State of Utah  
DEPARTMENT OF NATURAL RESOURCES  
DIVISION OF OIL, GAS AND MINING

RE: Determination That the Willow Creek Mine Site Can Be Reclaimed to the Approximate Original Contours With Emphasis On the Cut Slopes on the Schoolhouse Canyon Road, Plateau Mining Corporation, Willow Creek Mine.  
[REDACTED]

TECHNICAL MEMO

**Figure 1**

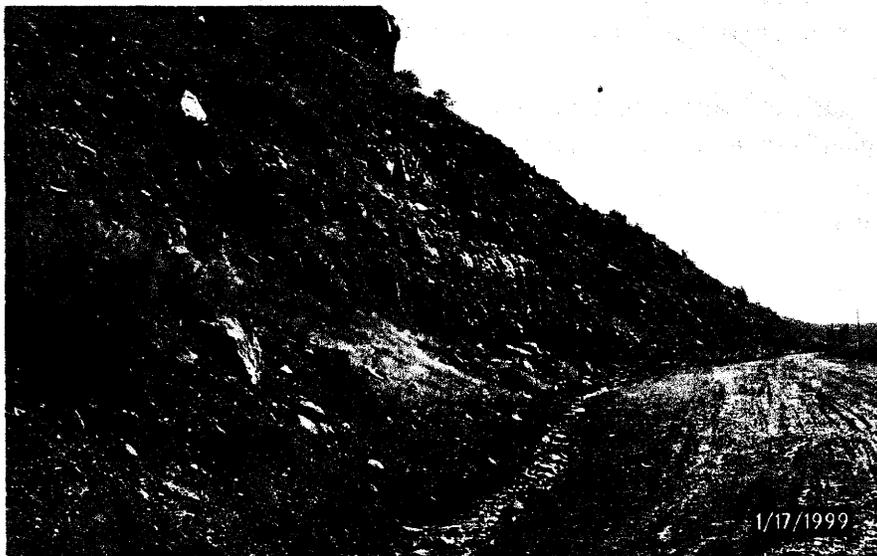
The cut slopes and surrounding topography are shown on Figure 1. The cut slope remnants will be similar but smaller than the natural cliffs in the area. The cut slope remnants that will remain after reclamation is similar to those that have already been approved by the Division and OSM at other sites.

The main requirement for cut slope retention is that the slopes are geotechnically stable. Figures 1 and 2 show the road cut was made in bedrock. The Division considers cut slopes in bed rock to be stable unless shown otherwise. The cut slope has existed for 23 years and there is no sign of instability.

**Figure 2**

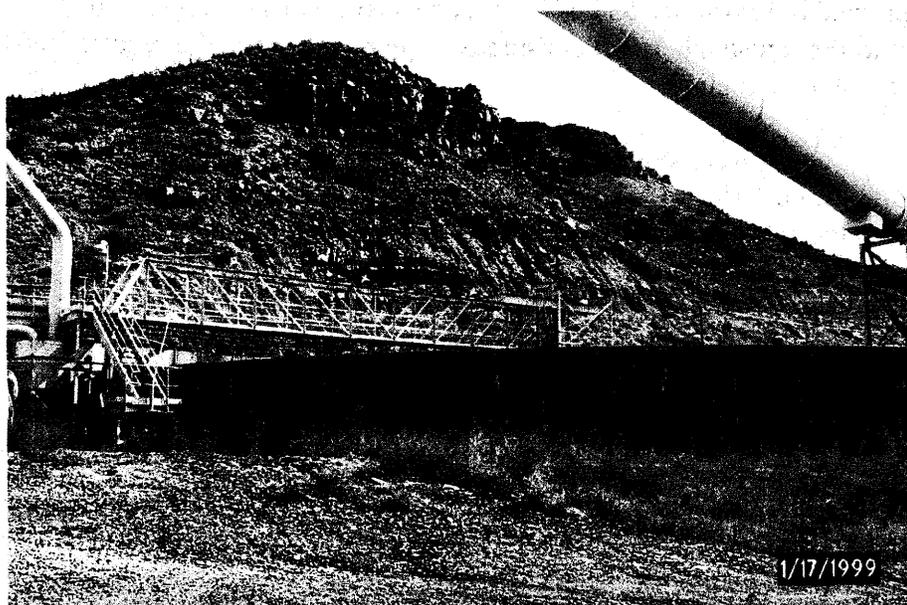
Figure 2 shows the cut slope for the access road. The cut slope was made in bedrock, which will remain stable in the present configuration.
